Access Compliance Report

Public Rights-of-Way

(Curb Ramps)

Intersection ID: 42737	Main Street: CALDWELL_FOREST_DR	Cross Street: CARLEEN_WAY_DR	Location: S
ADA ID: F06736CFB139	Ramp Type: PerpDiag	Initial Pass/Fail: Fail	Overall Compliance: No
			Severity Score: 33.75

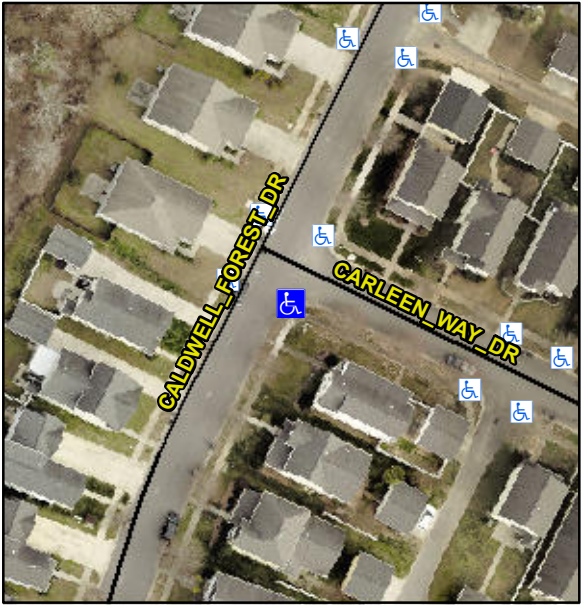
Codes/Mitigation Info/Possible Solution			Field Measurements/Component Compliance		
	Possible Solutions:		Compliance	Description	Data
	Remove & Replace Curb Ramp With Two New Directional Ramps or Equivalent.		No	Ramp Length (in)	49.0
			No	Ramp Width (in)	47.0
			N/A	Flare Type LT	N/A
			N/A	Flare Slope LT (%)	N/A
			N/A	Flare Traversable LT?	N/A
			N/A	Landing Length (in)	N/A
			N/A	Landing Width (in)	N/A
			N/A	Landing Slope (%)	N/A
			N/A	Landing X Slope (%)	N/A
			N/A	Landing Curb? (Y/N)	N/A
			N/A	Shared Landing?	N/A
			N/A	Gutter Ponding?	N/A
			N/A	Gutter Lip Ht (in)	N/A
			N/A	Painted X Walk1?	No
				X Walk 1 Direction	To N
			N/A	X Walk 1 Width (in)	N/A
				X Walk 1 Slope (%)	3.3
				X Walk 1 X Slope (%)	2.3
			N/A	Ramp inside XWalk1?	N/A
<p>Surveyor Notes:</p> <p>N/A</p> <p>PROW/ADA:</p> <p>R304.5.1, R304.2.2</p>			N/A	Flare Type RT	N/A
			N/A	Flare Slope RT (%)	N/A
			N/A	Flare Traversable RT?	N/A
			N/A	DWS Provided?	N/A

N/A	DWS Contrast?	N/A
			N/A	DWS Length (in)	N/A
			N/A	DWS Full Width?	N/A
			N/A	DWS Offset (in)	N/A
			N/A	Gutter Slope (%)	N/A
			N/A	Gutter X Slope (%)	N/A
			N/A	Painted X Walk2?	No
				X Walk 2 Direction	To W
			N/A	X Walk 2 Width (in)	N/A
				X Walk 2 Slope (%)	0.4
				X Walk 2 X Slope (%)	1.7
			N/A	Ramp inside XWalk2?	N/A
			N/A	Clear Space?	N/A
			N/A	Clear Space to XWalk (in)	N/A
			N/A	Storm Grate/Utility Hazard?	N/A
				Storm Grate/Utility Type	
<p>Total Cost:</p> <p>\$ 3200.00</p>			N/A		N/A
			Yes	Surface Condition? (G/P)	Good
